pg 2 of 2 NEPA PLANNING FORM # 12.6

Sept. 2004

Attachment [1] – Detailed Description of Change

ENVIRONMENTAL EVALUATION FOR PPPL CHANGE PROPOSAL
CONSTRUCTION AND OPERATION OF NATIONAL COMPACT STELLERATOR EXPERIMENT (NCSX)
 TITLE OF CHANGE OR PROJECT

Laser-based GPS (WBS 187)

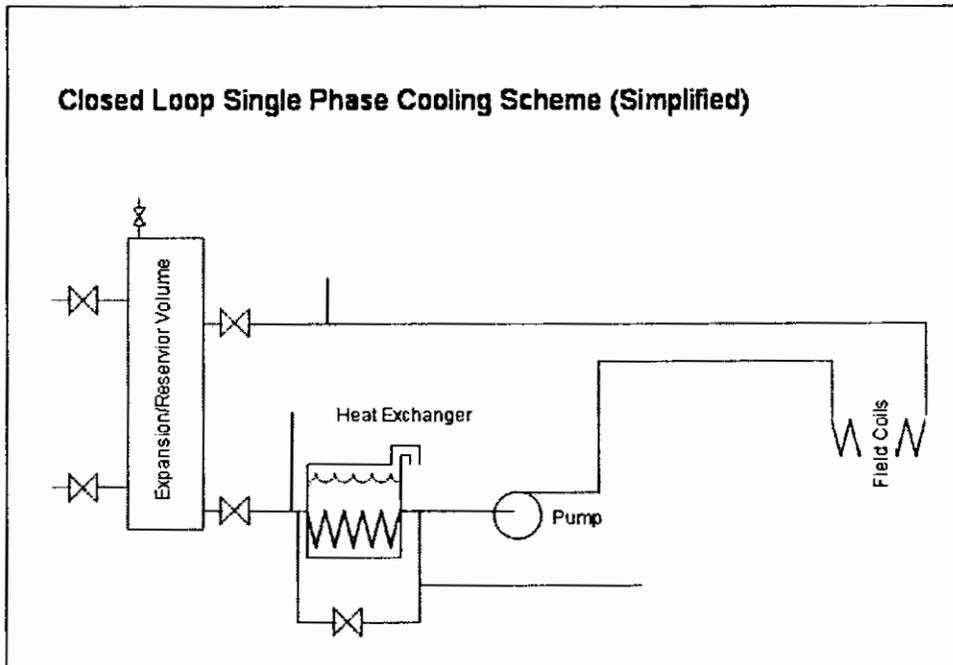
The laser-based GPS was eliminated saving \$129K. Metrology needs can be satisfied using two multi-link coordinate measurement machines (Romer arms) and one Leica laser tracker.

Cryogenic Cooling Supply (WBS 622)

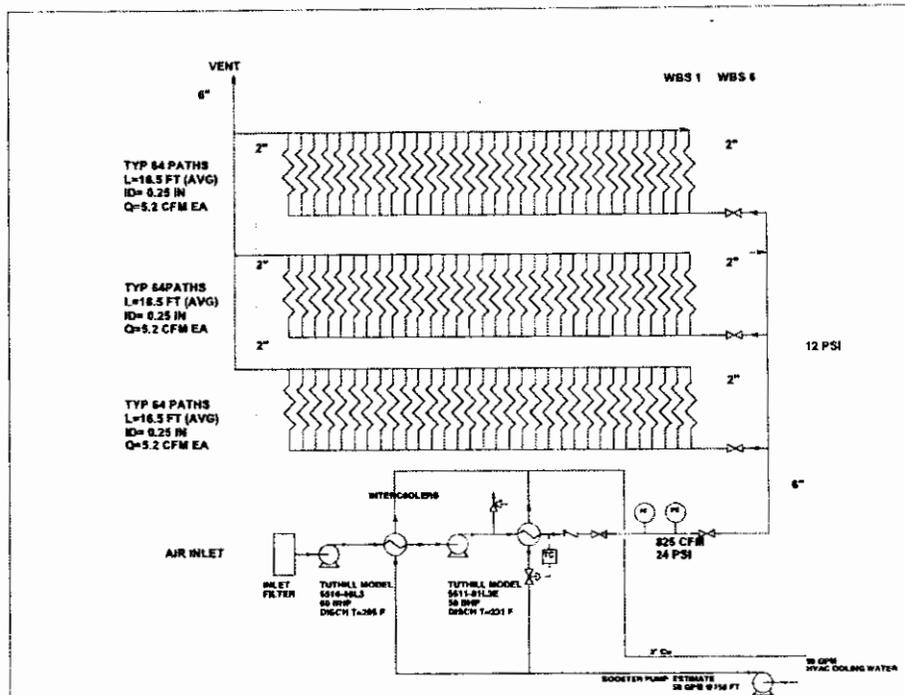
To meet CD-4 requirements, a simplified single phase approach is proposed that will cool the NCSX windings with liquid nitrogen that is prevented from boiling in the cooling circuits by an appropriate back-pressure valve and control scheme (see figure below). The back-pressure can be maintained at a useful level that remains less than the supply pressure from the 9200 gallon storage tank: The differential pressure between the tank and the back-pressure control drives flow through the winding's coolant passages. This low-cost design will allow enough heat rejection capacity to support recently-issued first plasma and field line mapping scenarios. A further cost-saving measure in this proposal
